**CREAKING NOISE FROM FRONT LOWER CONTROL ARM BUSHINGS**

**Bulletin No:** 02-001/15

**Last Issued:** 01/14/2015

- This bulletin supersedes the previous bulletin 02-005/14, issued on 12/12/14. The **REPAIR PROCEDURE** has been revised.
- Changes are noted below in Red beside the change bar.

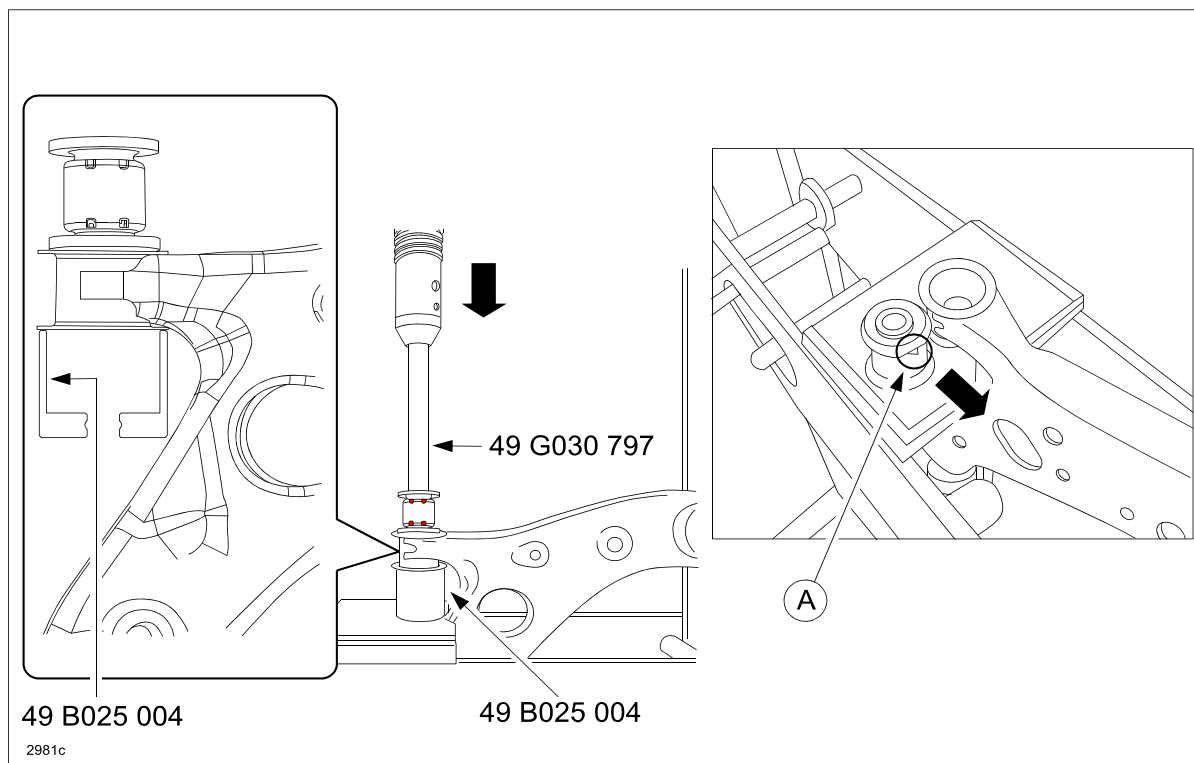
- Apply soap suds to the bushing to ease the installation.
- Always wipe off soap suds from the front lower control arm and bushing with a cloth.
- Install the bushing so the projection (A) is pointing toward the front of the vehicle.

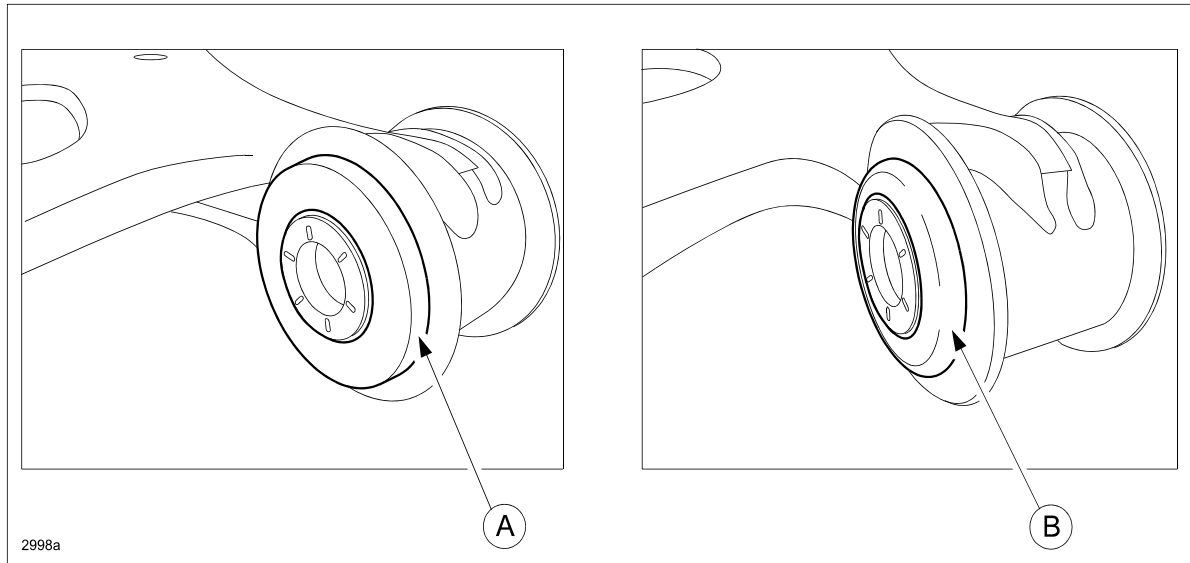
**CAUTION:** Make sure the bushing has been properly inserted by verifying that the bushing tab **IS FULLY EXPANDED**, as shown in the illustration to the left (A). The illustration to the right (B) shows an example of a bushing tab that **IS NOT FULLY EXPANDED**.
